Fire and Emergency New Zealand

Building Memorandum

Memo Issue 1
Date 10 June 2021
Design Review No 16665

Design Details	
Architect	Klein Limited
Fire Engineer	[REDACTED], Cross Fire
Fire Report Title	Fire Safety Design Southern Cross Hospitals Auckland Surgical Centre Ward Corridor A Upgrade
Fire Report Date	21/04/2021
Version	B
Identifier	2959

Figure 1 - Egress door from the Youth sleeping firecell(IFSC) - Extracted from the landscape plan IGL2.40.03

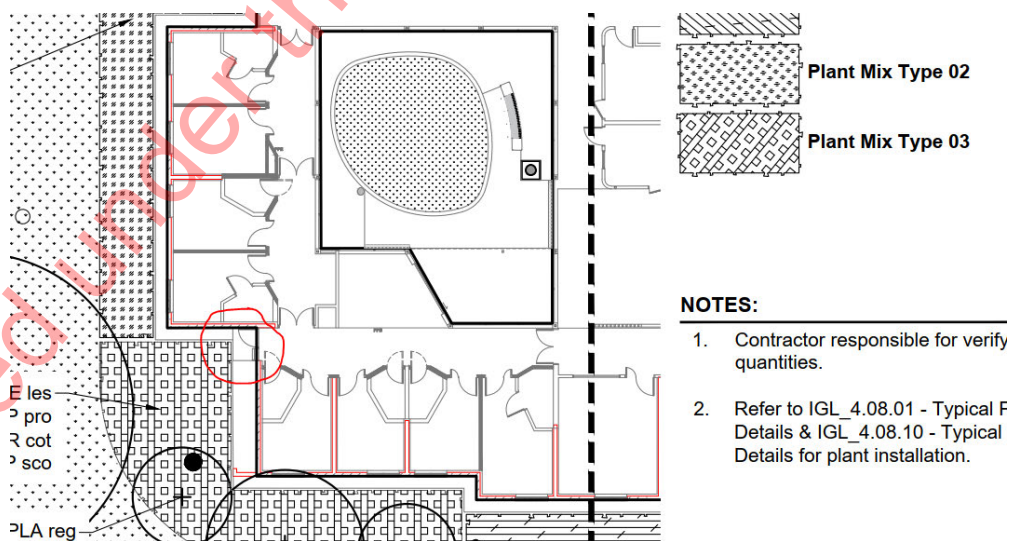
However, Fire and Emergency observes from the landscaping plans IGL_2.40.03, IGL_2.40.04, and IGL_1.10.00 that the exit doors from sleeping firecells and egress doors from the HCN building open on to a landscaping area as shown in the figures below and cannot verify whether a pathway from this door to a safe place has been provided.

Figure 4 – Fire separations surrounding upper floor - extracted from the fire drawing FSK14

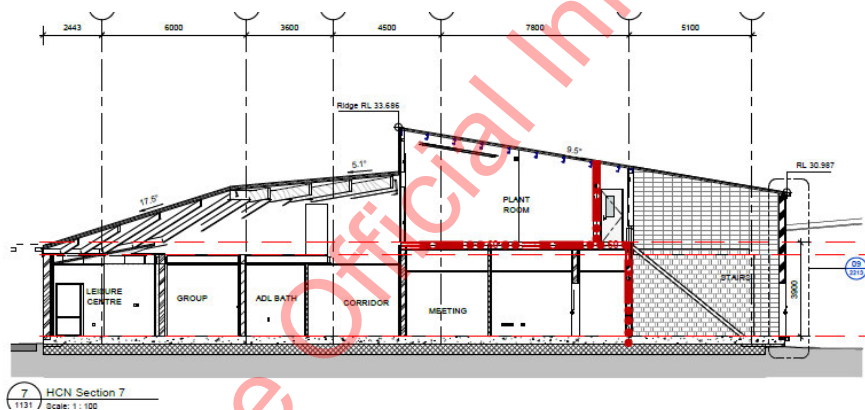
- a. For the HCN building, these drawings show the wall near gridline Y is to be a fire separation, but the wall between gridlines W and X is not shown to be a fire separation. It is unclear if this is a drawing error or a deliberate design intent. Should the upper floor not be fully fire separated then it should be treated as an intermediate floor and the fire report is silent on this aspect of the design. This is shown in Figure 4 below.

Figure 1: Excerpt from Fire Strategy Plan - showing location of zip screen doors (highlighted in clouds)

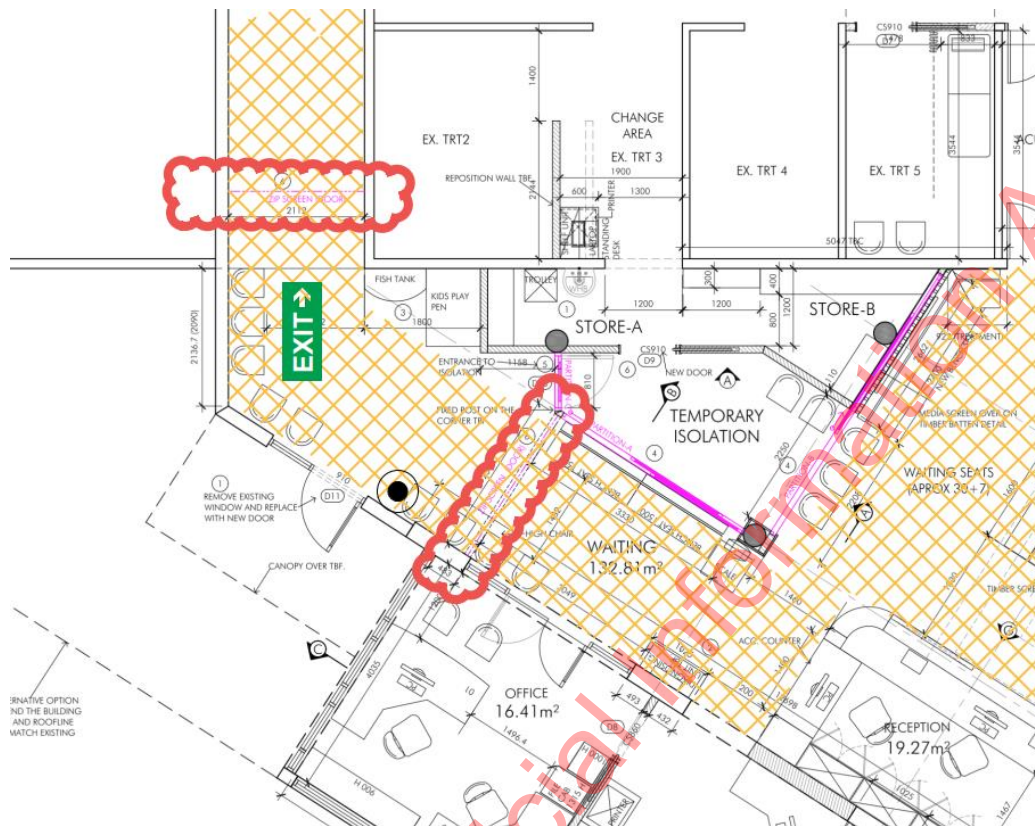
The fire strategy plan (sheet no 12086) indicates that there will be two zip screen doors within the revised waiting area. Zip screen doors shown in the clouds in figure 1 below

As the zip screen doors are located along a means of escape (the exit sign shown in the drawing directs occupants through the zip screen door), it should be established in the fire report how this construction meets the C/AS2, paragraph 3.15 requirements for doors located along escape routes. As new construction these doors should comply in full with any relevant Building Code requirements.

Figure 1 – Fire separation of Stair 3

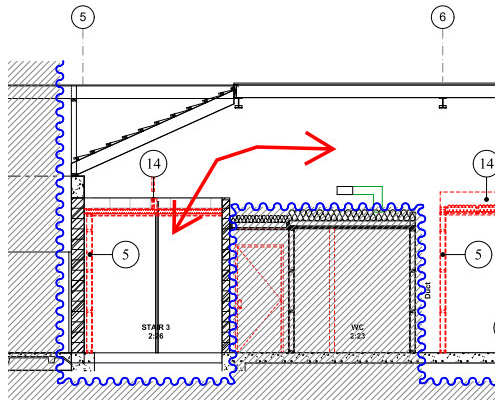
- b. Architectural drawing A401 indicates that the fire separation of Stair 3 does not extend to the roof of the building. From Note 14, the ceiling to the stair is proposed to be demolished, which connects Stair 3 to the demolition zone. Although the fire plans indicate a hoarding line constructed of non-combustible materials, this stair should be rectified to be compliant with the fire separation requirements of an exitway or the sprinkler standard, whichever is more onerous.

Figure 2 – Fire separation of Stair 4

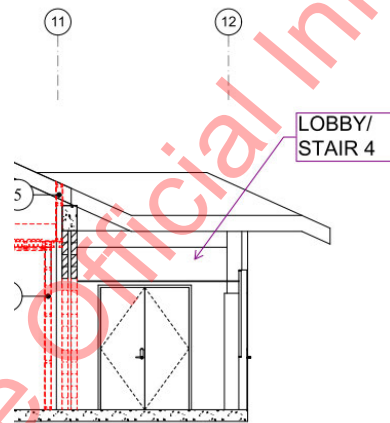
- c. Architectural drawing A401 indicates that the lobby wall which is part of Stair 4 will be demolished. As this wall is required to be fire-rated, it is unclear why the hoarding line is not fire-rated. In addition to being a designated egress route from the Level 2 demolition zone, Stair 4 also serves as a means of escape from the levels below, with Level 1 appearing to be a ward area with a more vulnerable population. Therefore, maintaining fire separation of this stair is necessary, particularly since a fire occurring within the demolition zone will not be sprinkler controlled.

Figure 1 – Unprotected openings between firecells

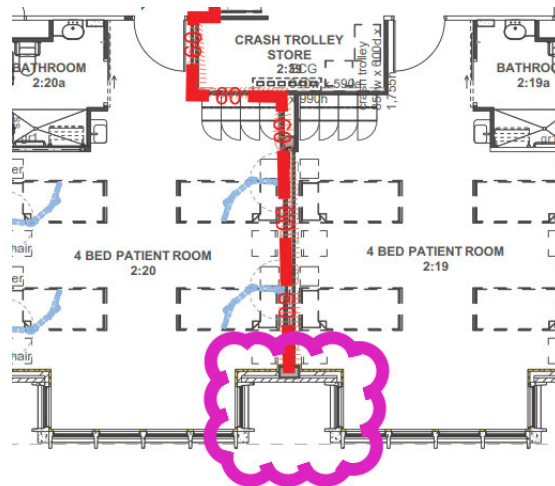
C/VM2 paragraph 4.5 requires horizontal fire spread to be addressed between firecells with sleeping occupancies. As architectural drawing A600 indicates that these windows are to be

replaced, an assessment of these windows is necessary and the design amended if required to prevent fire spread between the firecells.

Fire and Emergency advises the BCA to require the applicant to assess the risk of fire spread between firecells in order to demonstrate compliance with the Building Code.

Figure 1 – Unprotected openings between firecells

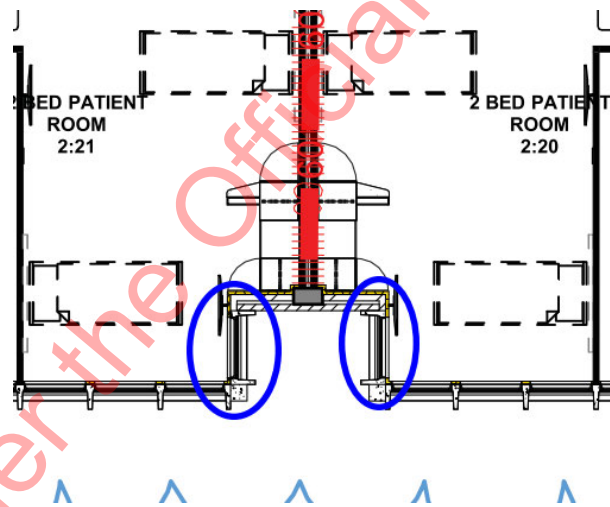
Fire and Emergency notes that there are bay windows along the western elevation that constitute unprotected openings between firecells. These are indicated in the mark-up in the figure below.

C/VM2 paragraph 4.5 requires horizontal fire spread to be addressed between firecells with sleeping occupancies. As architectural drawing A600 indicates that these windows are to be replaced, an assessment of these windows is necessary and the design amended if required to prevent fire spread between the firecells.

Fire and Emergency advises the BCA to require the applicant to assess the risk of fire spread between firecells in order to demonstrate compliance with the Building Code.

Figure 1 – Fire separation of Stair 3

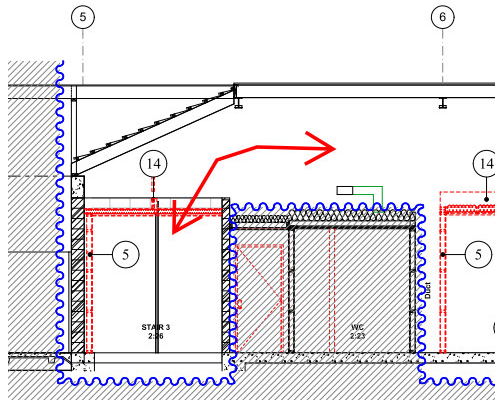
- b. Architectural drawing A401 indicates that the fire separation of Stair 3 does not extend to the roof of the building. From Note 14, the ceiling to the stair is proposed to be demolished, which connects Stair 3 to the demolition zone. Although the fire plans indicate a hoarding line constructed of non-combustible materials, this stair should be rectified to be compliant with the fire separation requirements of an exitway or the sprinkler standard, whichever is more onerous.

Figure 2 – Fire separation of Stair 4

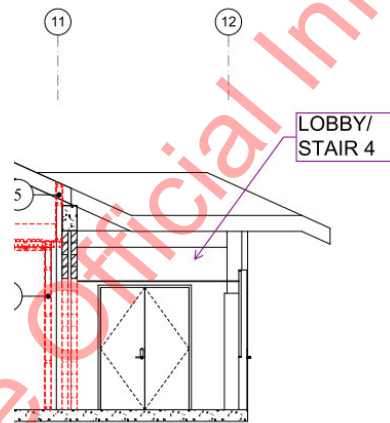
- c. Architectural drawing A401 indicates that the lobby wall which is part of Stair 4 will be demolished. As this wall is required to be fire-rated, it is unclear why the hoarding line is not fire-rated. In addition to being a designated egress route from the Level 2 demolition zone, Stair 4 also serves as a means of escape from the levels below, with Level 1 appearing to be a ward area with a more vulnerable population. Therefore, maintaining fire separation of this stair is necessary, particularly since a fire occurring within the demolition zone will not be sprinkler controlled.

The documentation provided does not indicate that the fire separation of the two exit stairs, which serves multiple levels of the building, will be maintained, and hence does not demonstrate compliance to the means of escape provisions of the Building Code.

Figure 1 - Fire drawing FES-01

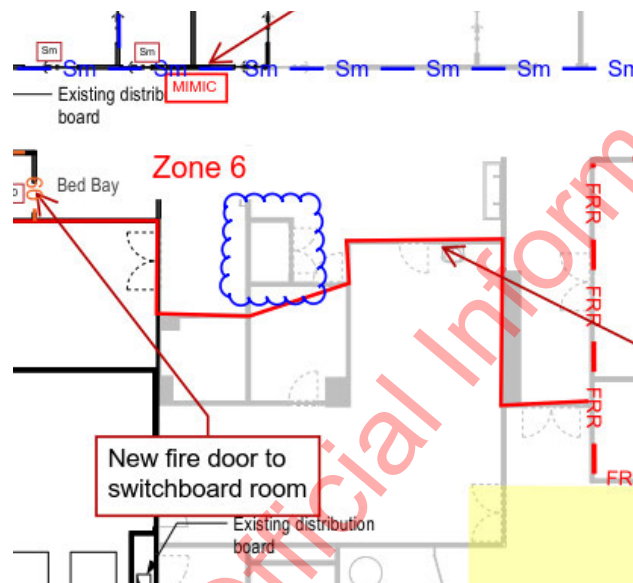
The corridor outside the operating theatres is required to be maintained as fire sterile as possible as the only escape route from the operating theatres is via the corridor. Therefore, no combustibles such as storage of bedding, towels, etc. or the storage of any other combustible is permitted. This potential issue was discussed at length during the FEB stage, and it was agreed that maintaining the corridor as fire sterile as possible is essential due to it being the only escape route for the theatre occupants. It was also agreed that all combustibles would be housed within a specific fire separated storage room.

However, Fire and Emergency notes that it is unclear if all potential fire risk areas have been appropriately fire separated from the corridor escape route. Refer to snip below taken from the fire drawings:

Figure 1: Excerpt from fire drawing FEV201 showing fire load within the theatre corridor

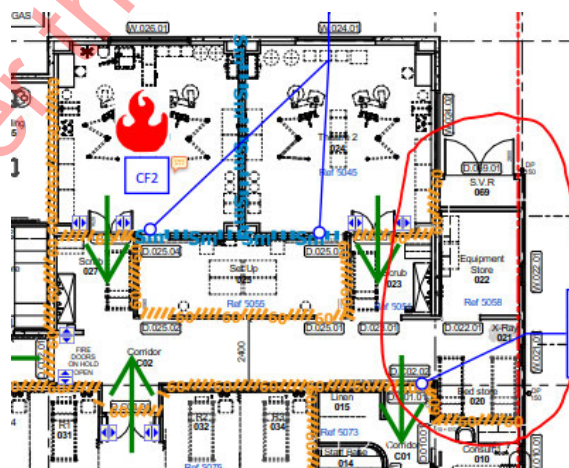
However, Fire and Emergency observes from the fire plan FEV201 that there is a non-fire separated equipment store and a bed store alcove as shown below.

Therefore, Fire and Emergency observes that the corridor area is not reasonably sterile. A challenging fire in the corridor is more onerous than the other challenging fire locations

Figure 2: Excerpt from architectural drawing A-1002 showing means of escape from first floor plant room

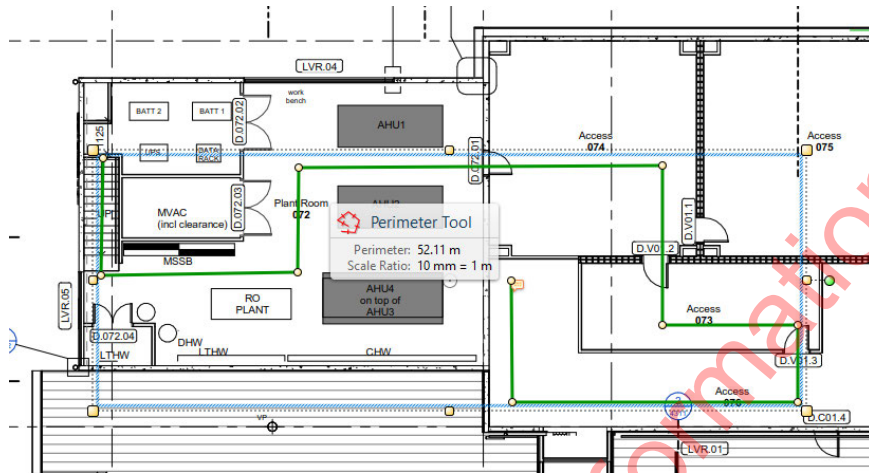
Fire and Emergency observes from the architectural plan A-1002 that there are access rooms next to the plant room on the first floor which have not been shown on the fire plans and the rooms are served by a single means of escape which exceeds 50 metres.

Therefore, Fire and Emergency notes that the single means of escape from the first floor plant room does not comply with the C/VM2, Paragraph 4.1 BE scenario.

Figure 3: Mechanical drawing M203 excerpt showing lack of fire and smoke dampers along fire separation (circled)

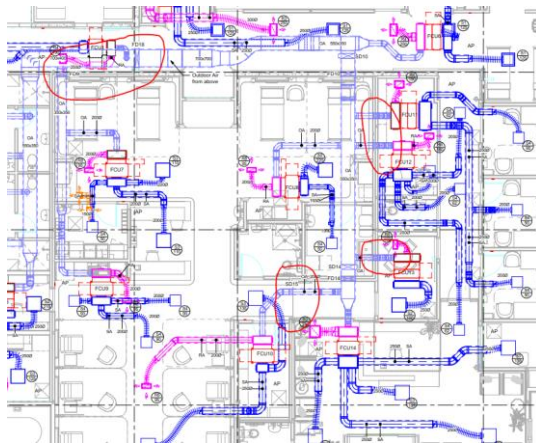
- b. **Provision of smoke and fire dampers** - Section 5.6.7 of the fire report states that throughout the building motorised smoke and fire dampers are required to be installed where HVAC ductwork penetrates through fire separations.

However, Fire and Emergency observes from the mechanical plans that some of ducts penetrating fire separations have not been indicated as provided with smoke and fire dampers. See examples in figures 3 and 4 below.

Figure 1 - Distance between two egress doors from the operating theatre firecell

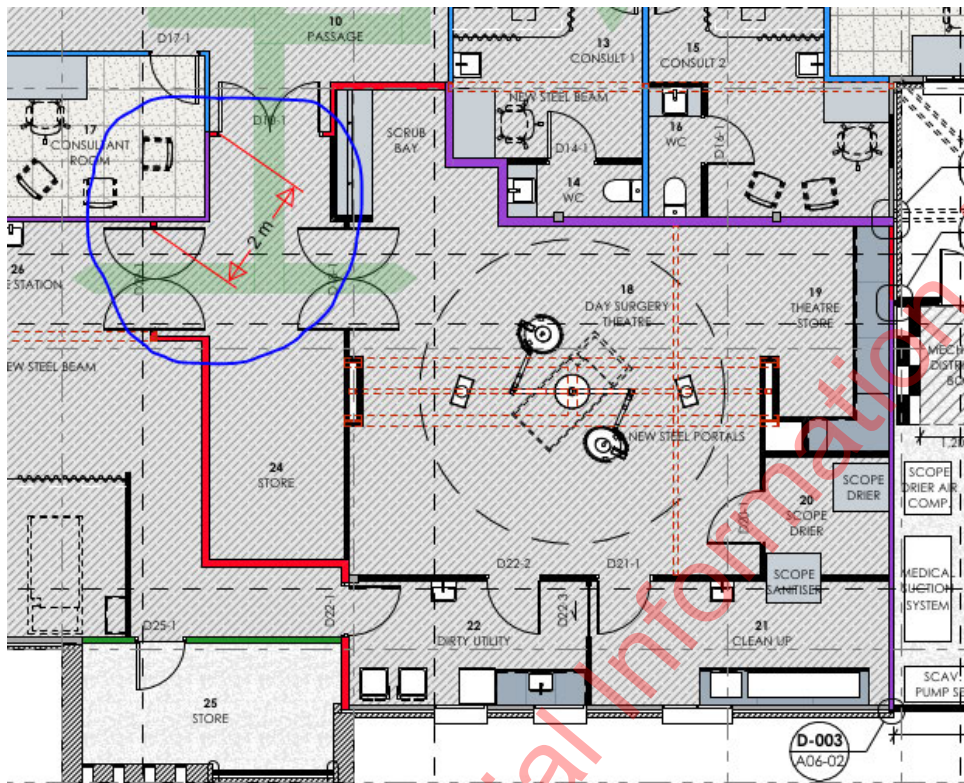
However, Fire and emergency observes from the architectural plan that the distance between the two designated egress doors is less than 8 metres. Consequently, these cannot be considered alternative egress paths.

Fire and Emergency notes that, where two or more exits are required to be provided, those exits are either to be separated more than 8 metres or by smoke separations in accordance with C/AS2, paragraph 3.6.2.

Figure 2 - Fire dampers on ducts penetrating fire separations

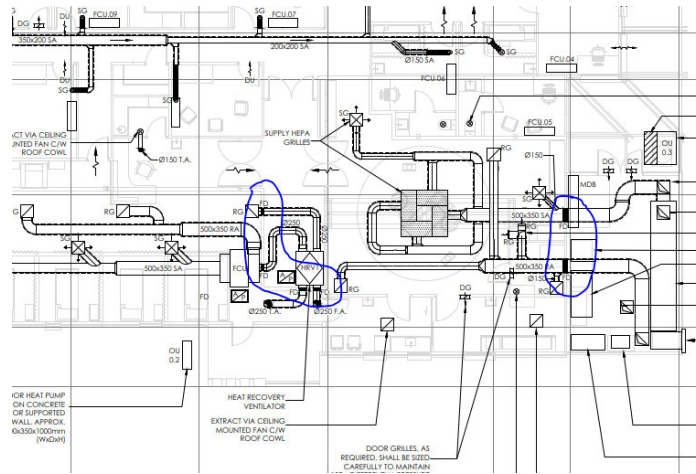
However, Fire and emergency cannot verify from the mechanical plan M101 that the specified dampers are fire and smoke dampers as opposed to standard fire dampers.

Fire and Emergency notes that fire separation requirement indicated in the fire report should be reflected in the other discipline's documentation.

Figure 1 - Location of discontinued fire rated wall between the procedure suite and the reception area - Extracted from the architectural plan A3.11

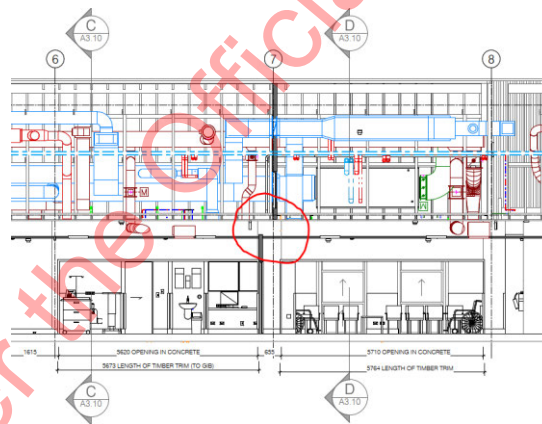
However, Fire and Emergency cannot verify from the architectural plan A3.11 that the fire rated walls (corridor wall with a fire door) are continuous from the floor to the roof line and it appears that there is discontinuation as shown below.

Figure 1 - Locations of exit signs - Extracted from the electrical plan EI-1031

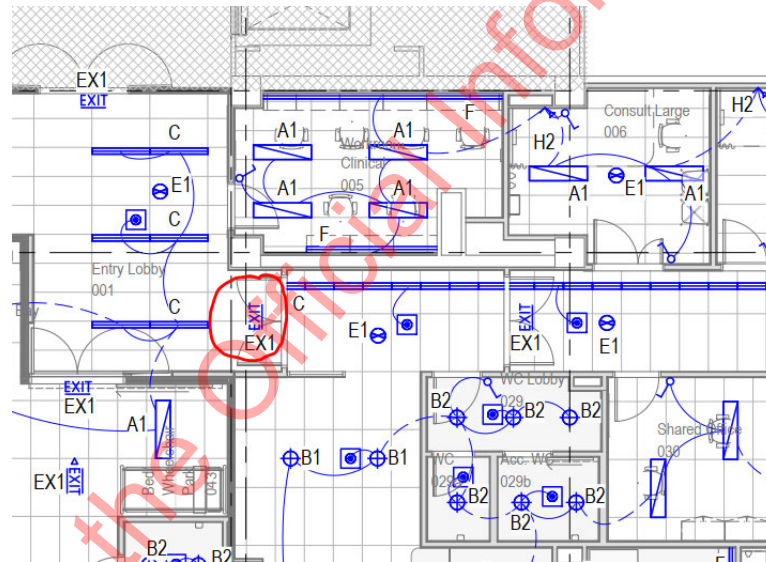
Fire and Emergency observes that the exit sign locations at the north side of Urology department shown on the fire plan is different from that shown on the electrical plan EI-1031.

The exit sign circled in red in the figure above should be re-located to the other side of the double leaf door as shown on the fire plan to meet the design intent.

Figure 1 - Future War rooms - Extracted from the architectural plan A303

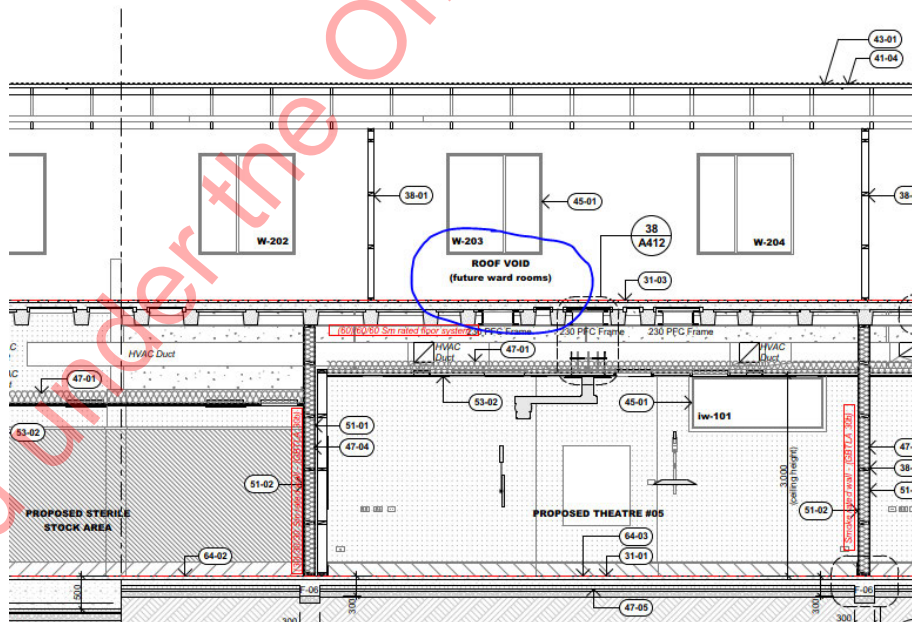
However, Fire and Emergency observes from the architectural plan A303 that the upper floor is to be used for ward rooms in the future and thus cannot verify the statement that this is just a service area (for maintenance).

Notwithstanding the above, Fire and Emergency notes that the external egress stair is the only egress route from the upper floor space (no matter the usage of the space) and therefore, occupants in the space should be properly protected from the fire in any adjacent area and should be assessed.
